Alaska DMT Software Revision 3.00 Evaluation

December 3, 2013

100397 was used in the evaluation

5a

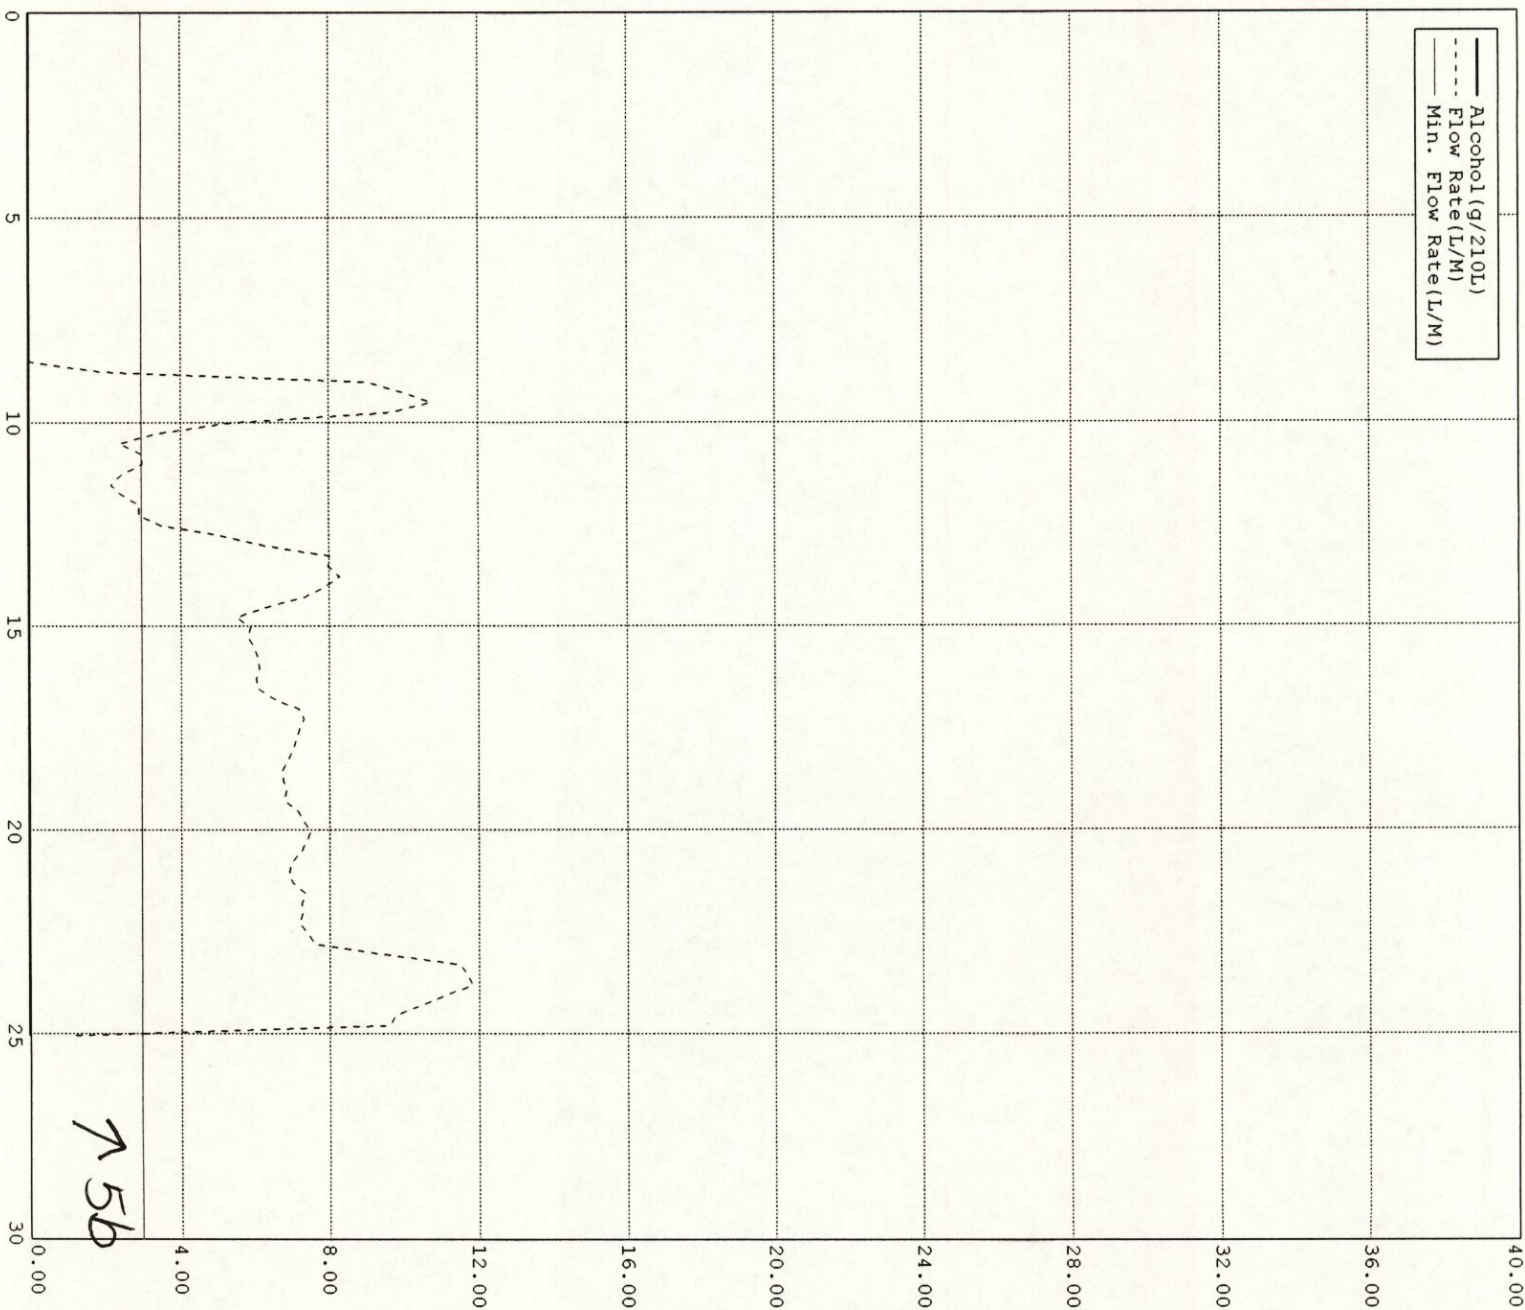
5. Ran a non-drinking complete subject test.
 - a. #7 from request list the volume printed on the subject sample line
 - b. #9 from the request list the minimum flow line was printed at 3.00 L/min

leal
 7/a

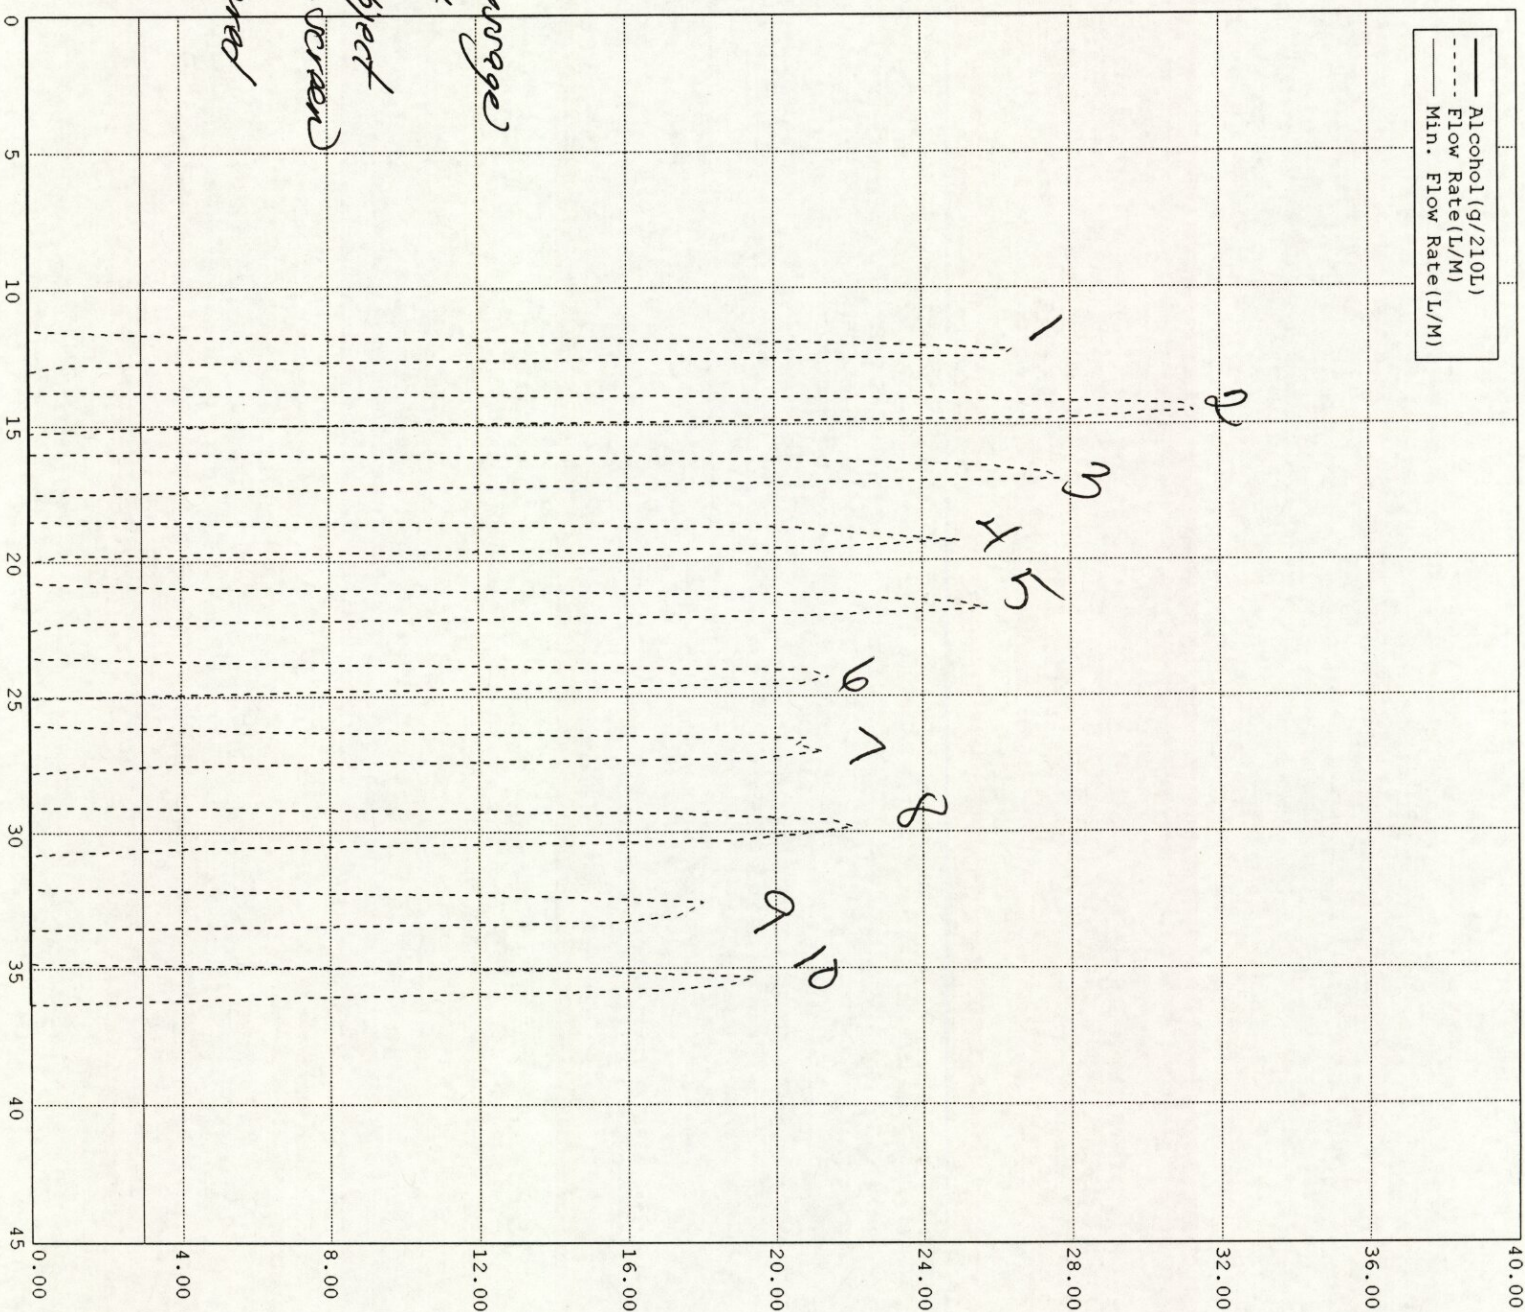
Maximum Attempts Exceeded

- Confirmed Max Attempt Message
- Confirmed not completed test message
- Confirmed signature bar present
- Confirmed press [OK] to test subject again takes you to data entry screen
- Confirmed status message triggered after 10 attempts

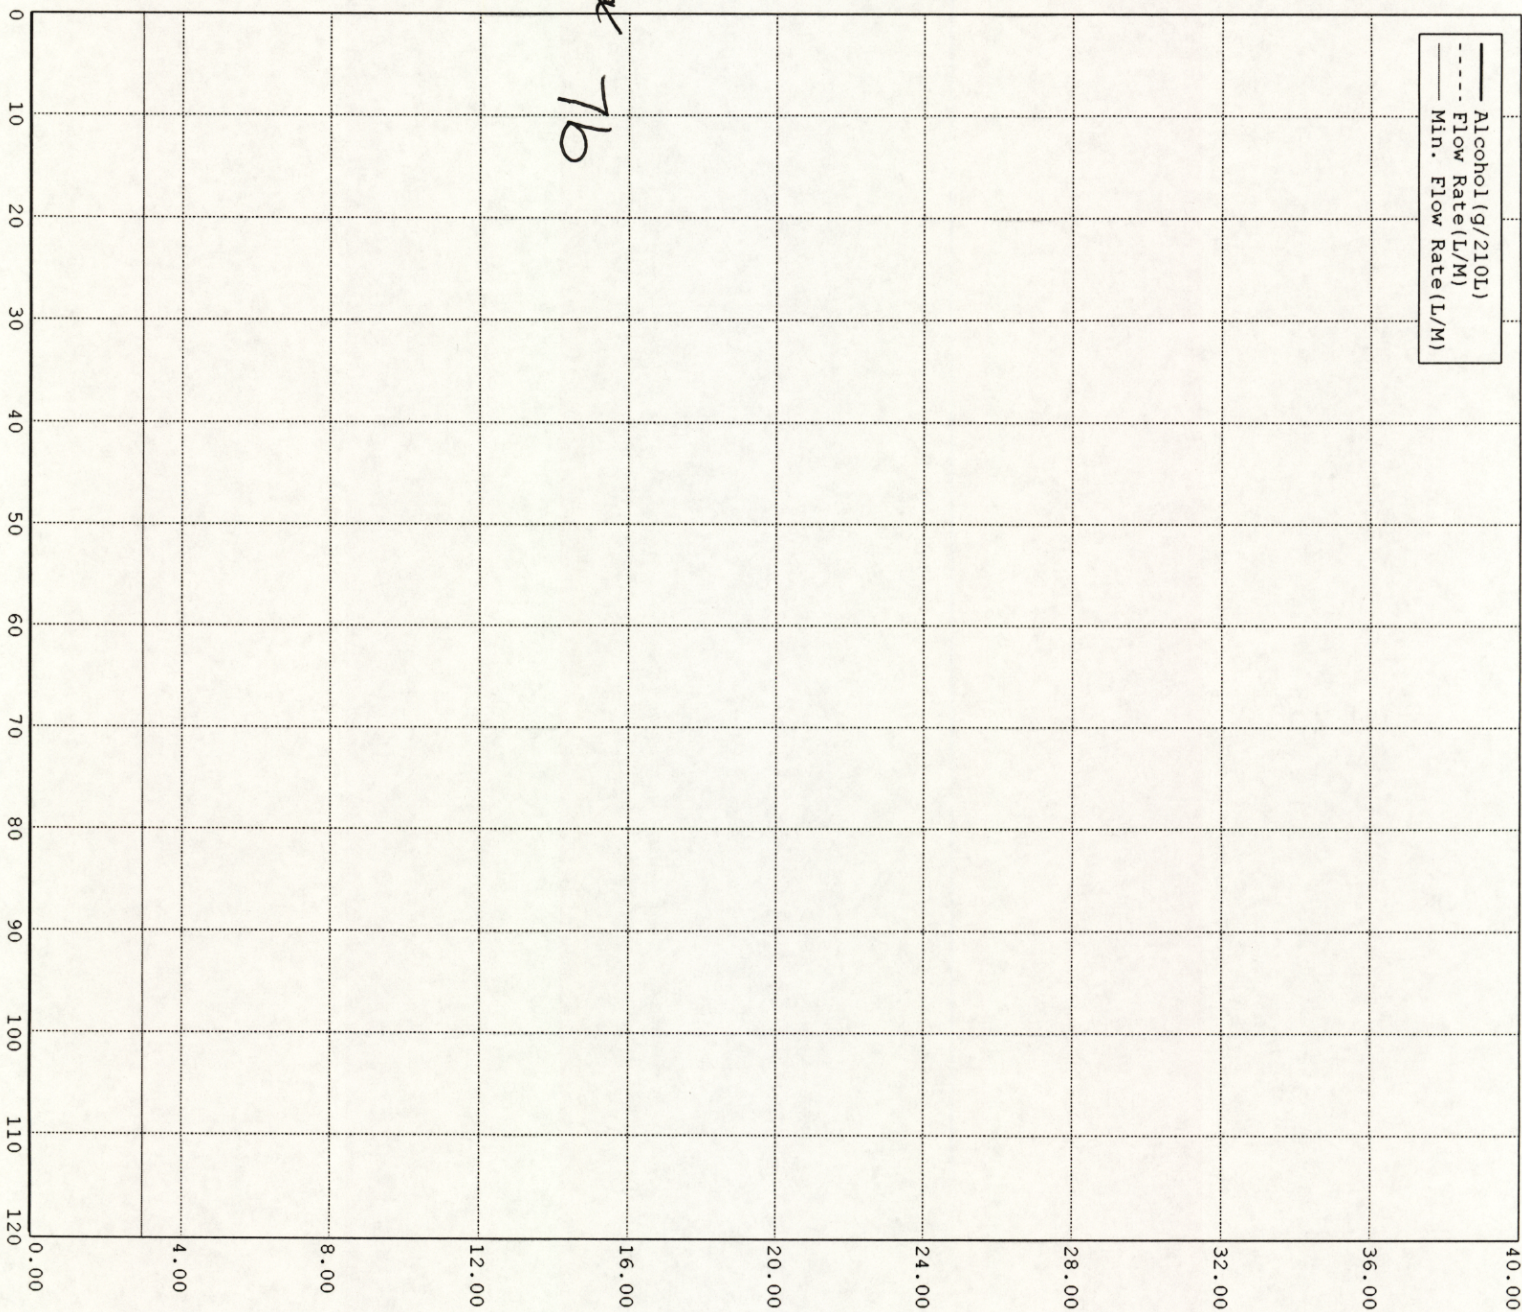
*Confirmed status message box
 (no change to wording)
 confirmed press [ue] to not
 test the subject again.*

7c \$10

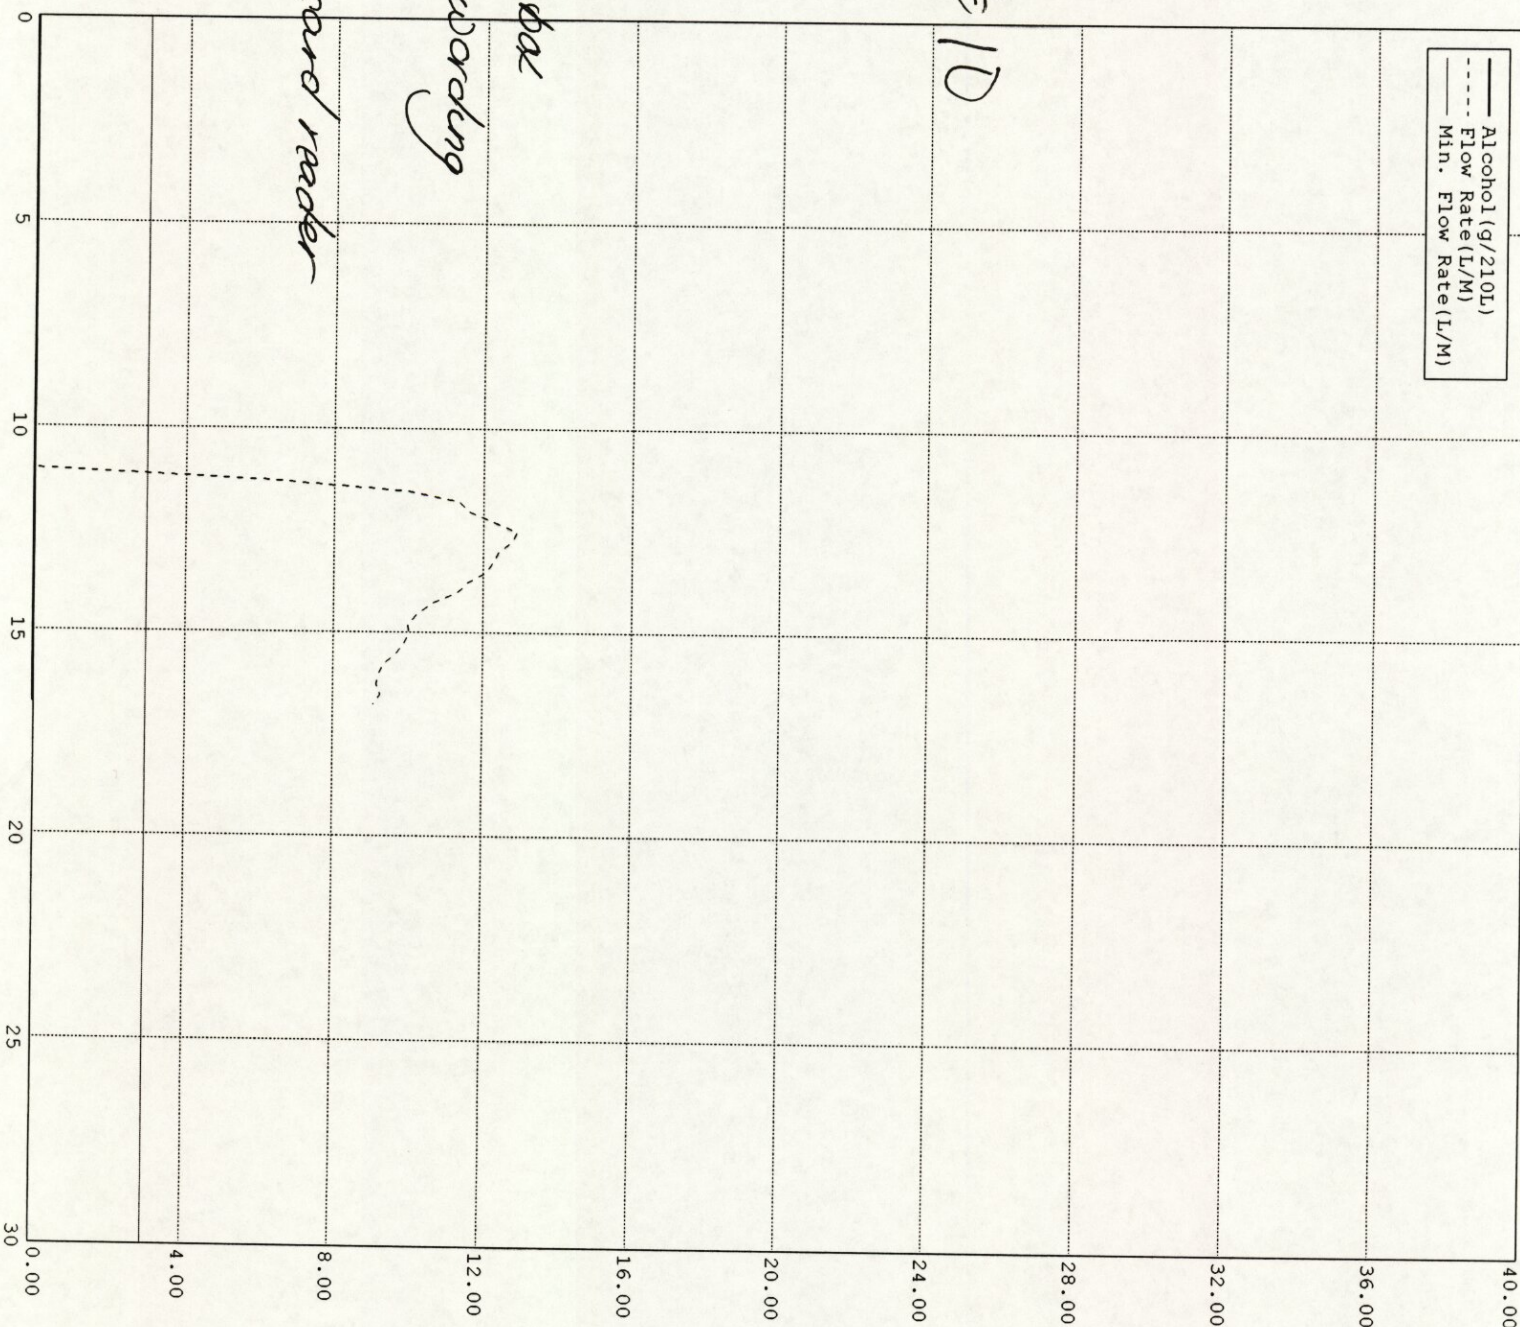
- RFI during subject test*
- *Confirmed status message box*
 - *and RFI status message appearing*
 - *confirmed signature box*
 - *Confirmed drivers license card reader*

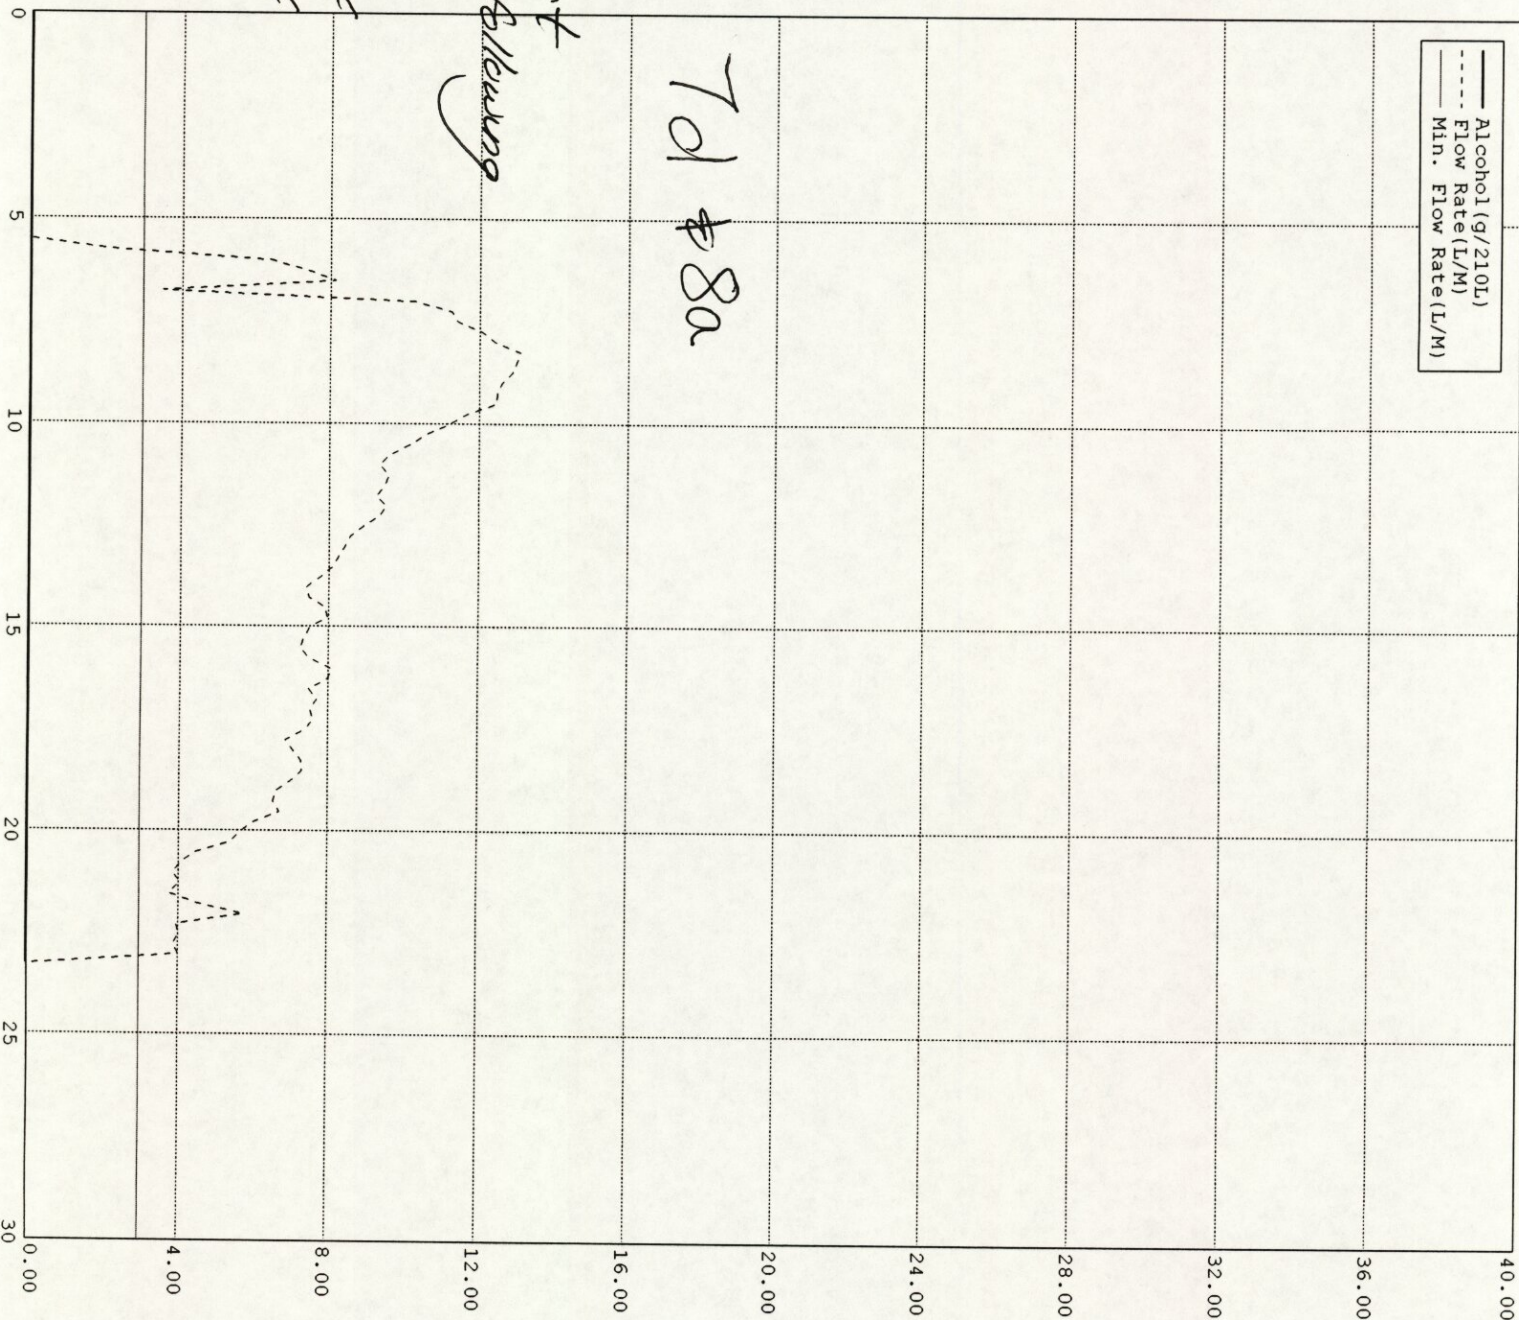
- Confirmed xxx to subject test on test with status msg following accepted sample.
- Confirmed status message bar and RFI status message bar.
- Confirmed signature bar
